**CITY OF CARPINTERIA
ARCHITECTURAL REVIEW BOARD
Meeting of October 16, 2014**

**COMMUNITY DEVELOPMENT DEPARTMENT
PROJECT REVIEW**

Project: 14-1730-ARB/CDP **Planner:** Steve Goggia
Address: 1289 Cramer Circle
APN: 003-103-002
Zoning: Single Family Residential (4-R-1)
Applicant: James Macari for MTI Capital, Inc.

Project Review: Conceptual
 Preliminary
 Final

SHEET TITLE
EXTERIOR ELEVATIONS

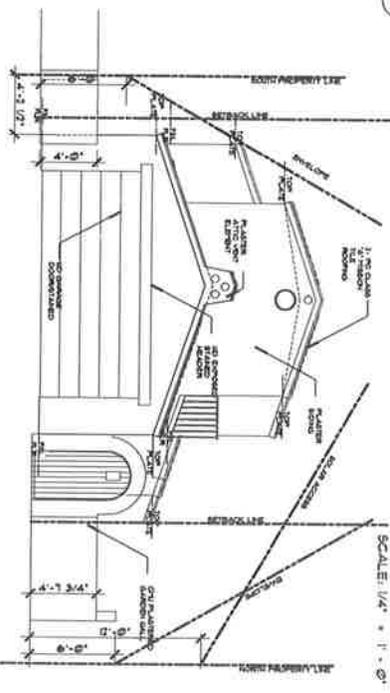
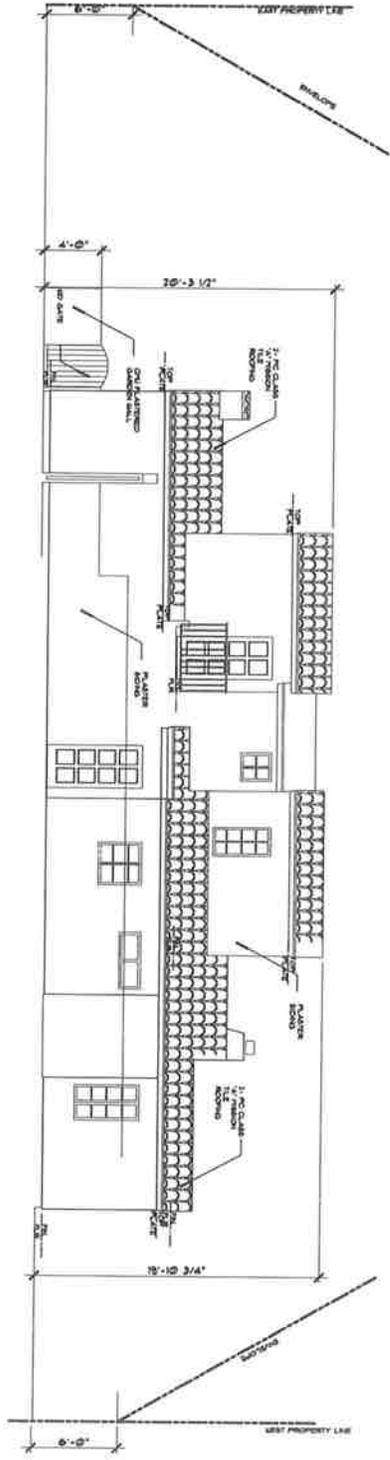
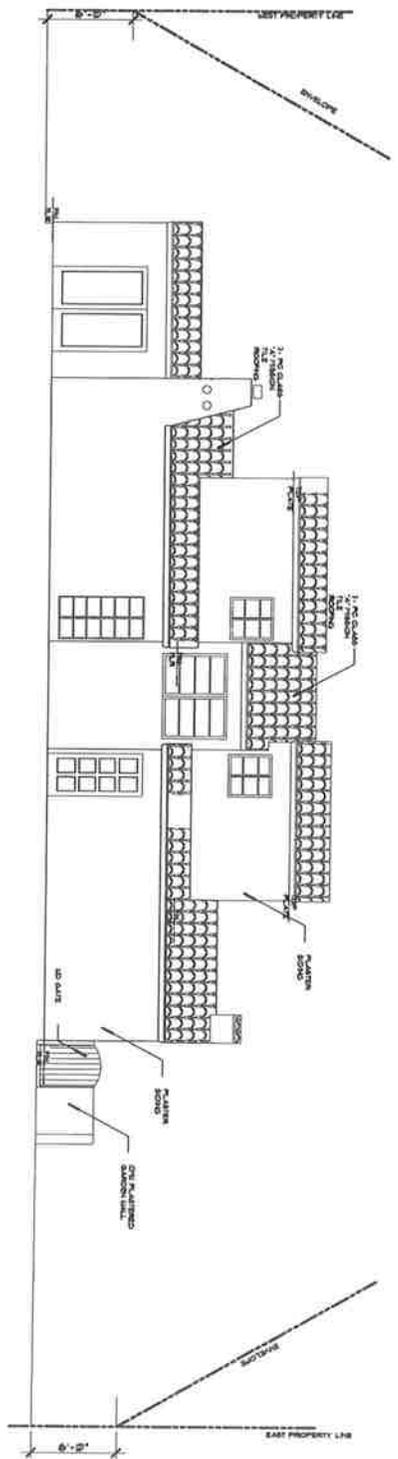
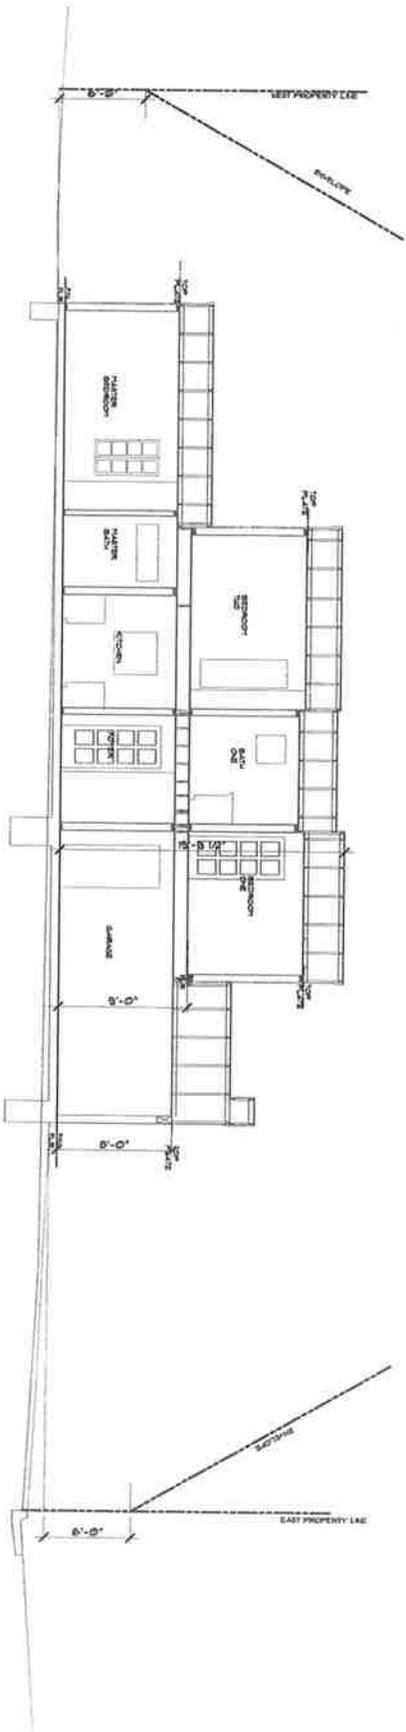
Consistency with the Encroachment Plane and Solar Access guidelines are shown on Sheets A3.0 and A5.0 of the architectural sheet set.
